DEPARTMENT OF MECHANICAL,  
AEROSPACE, AND NUCLEAR ENGINEERING

RCF 08-04  
July 28, 2008

Re: Response to Request for Additional Information

## RPI Responses to RAI dated March 21, 2008

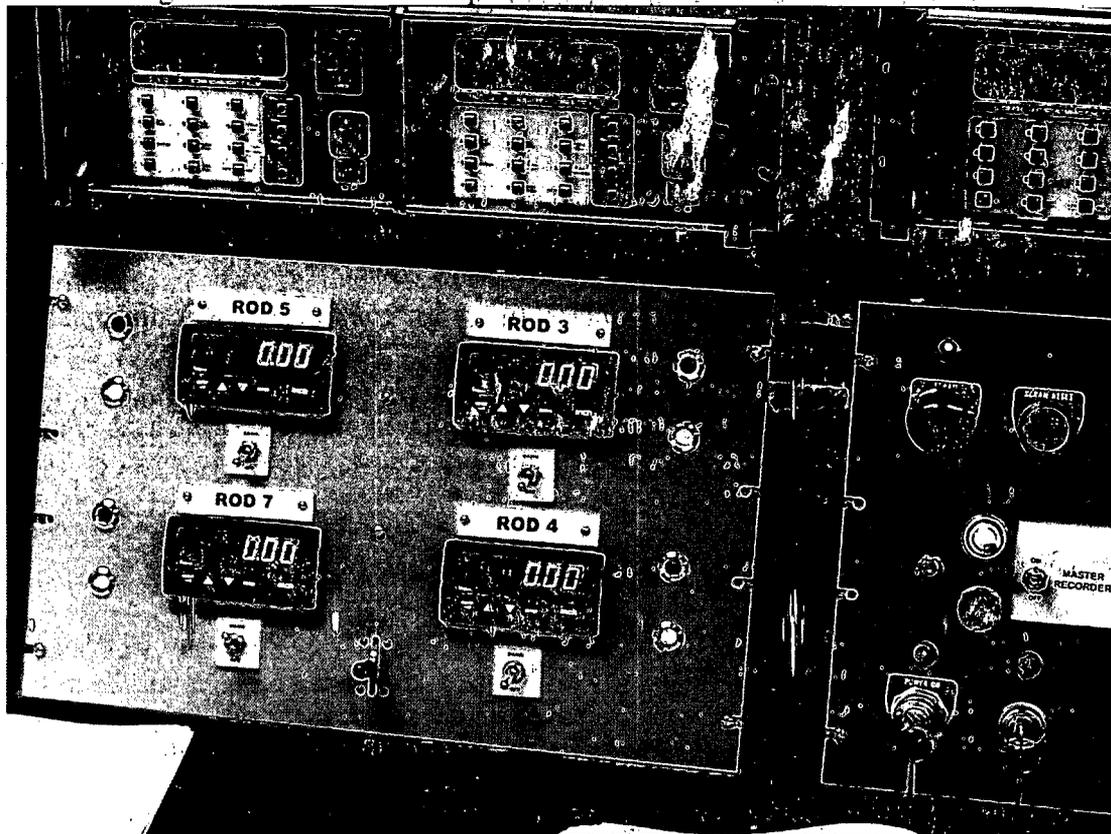
7.4 Section 7.6, Control Console and Display Instruments. Provide a more detailed discussion of the instruments, controls, and indications provided on the main control console.

RPI Response – The main control panel is known as CP-1. Electrical power for CP-1 comes from the building lighting panel. CP-1 displays include the position of the four control rods, including lights indication rods at the top or rods at the bottom. The shim switch for the control rods is located on the same section of panel as the rod position indicators. Each rod also has a switch to select control to the rod shim switch. All or any one of the rods may be selected. Thus rods may be moved in any combination desired from the single shim switch. See the photo below.

Revised Fig. 13.2:

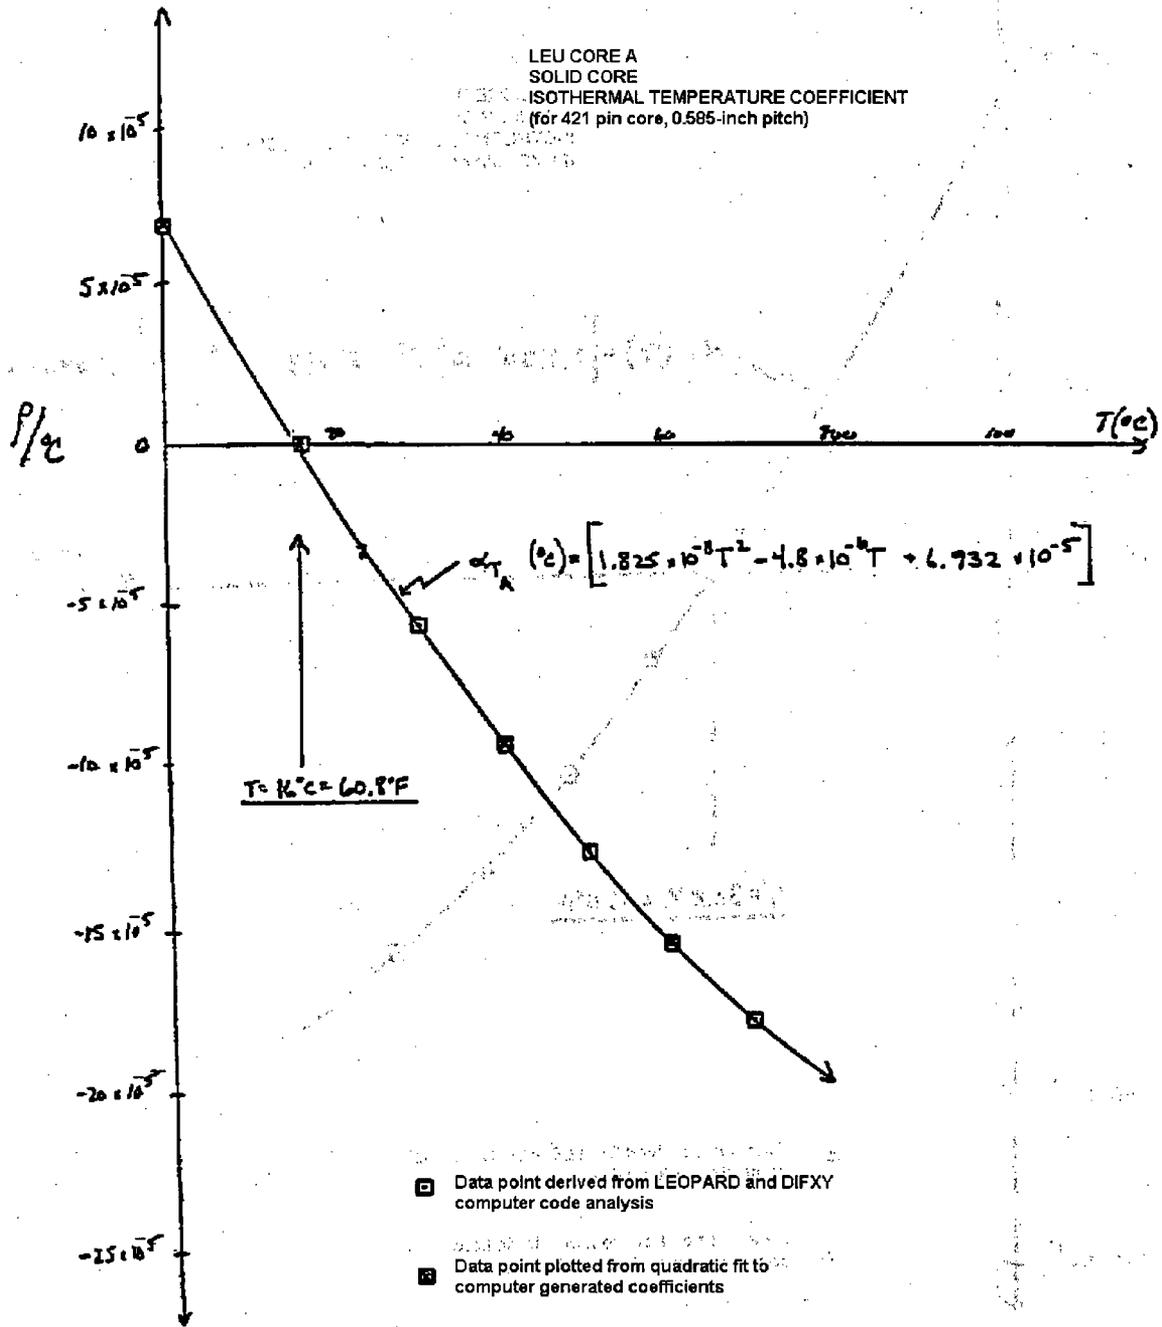
b. On Figures 13.2 and 13.3 the temperature coefficient shows a positive exponent ( $\times 10^5$ ) which is not consistent with the equation. Please correct.

RPI Response - Figure will be changed (see revised Figure 13.2 below) in the next SAR update.

Revised Fig. 13.3:

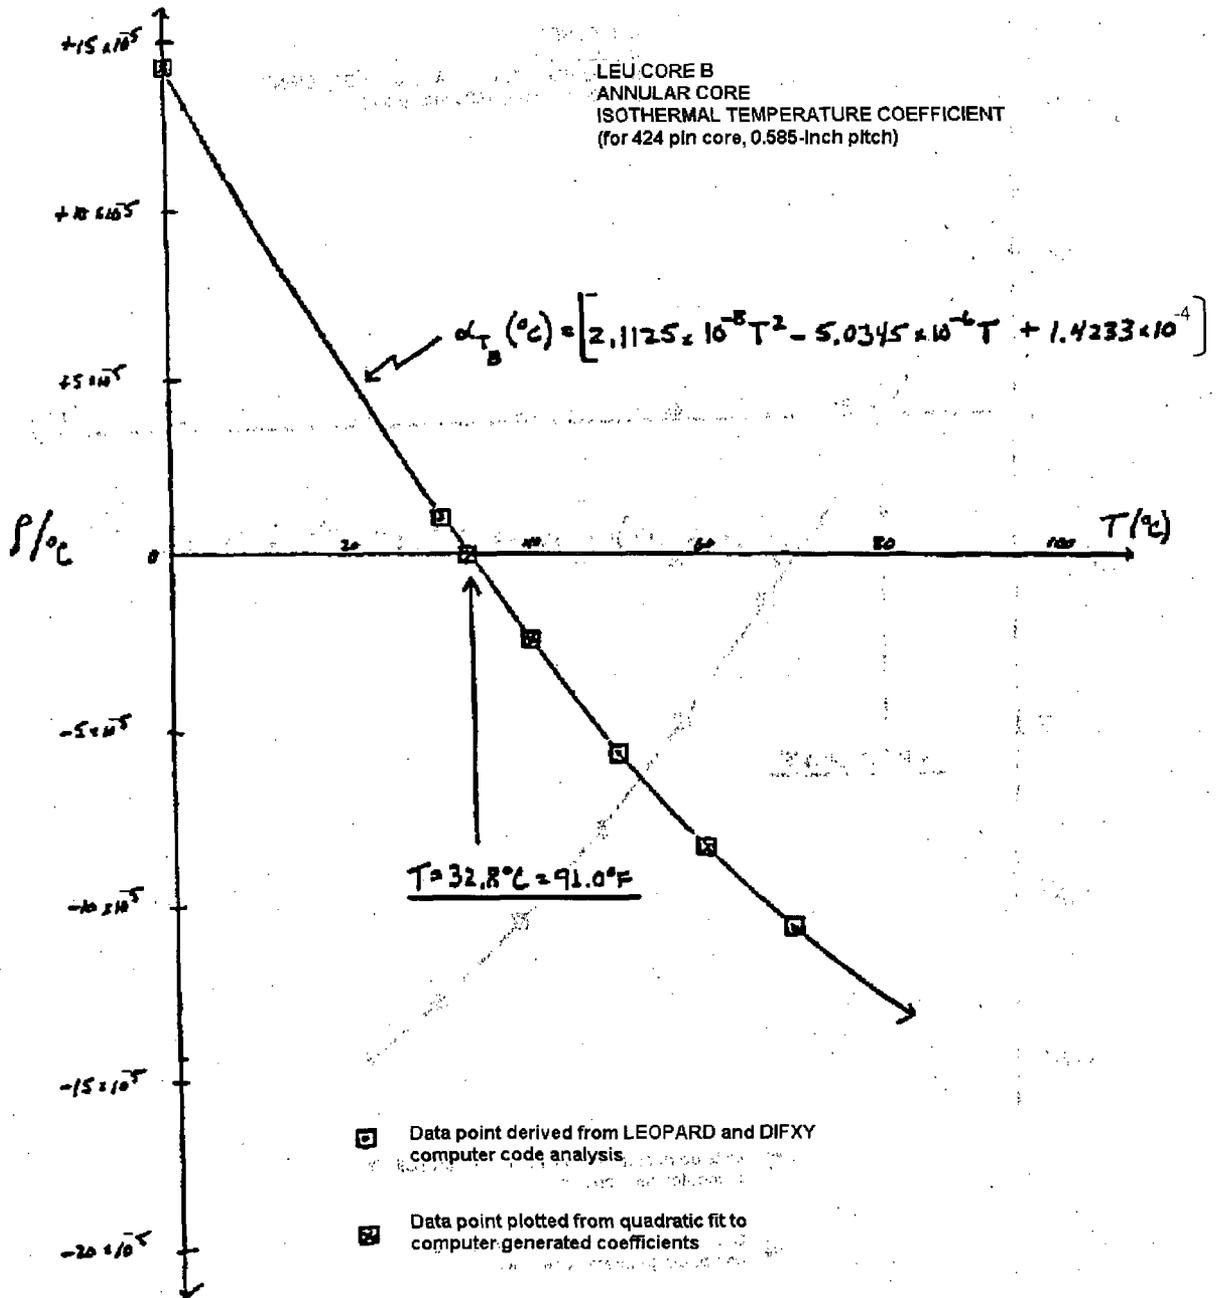
c. On Figure 13.3 the final exponent (-4) of the equation is missing, possibly a photocopying artifact. Please correct.

RPI Response - Figure will be changed (see revised Figure 13.3 below) in the next SAR update.

Figure 12.1: Facility Organization

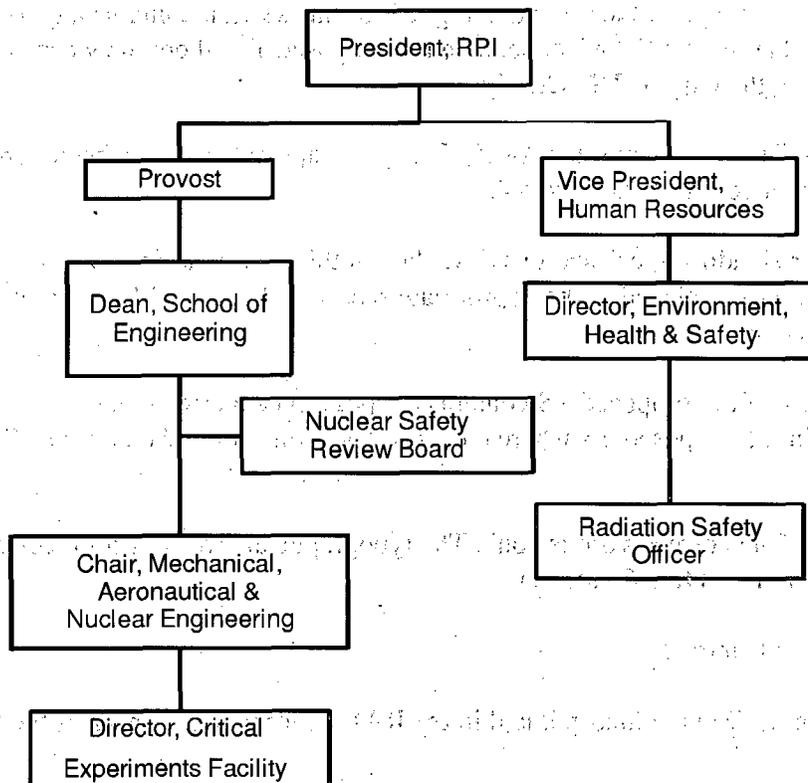
12.3 SAR Section 12.1, Organization, and TS Section 6.1, Organization. The organization illustrated in Figure 12.1 of the SAR is different than that in Figure A1 of the TS. Please resolve those differences and justify the structure.

The revised Chapter 12 and Technical Specifications have corrected the organizational chart and harmonized the terminology related to the radiation safety program.
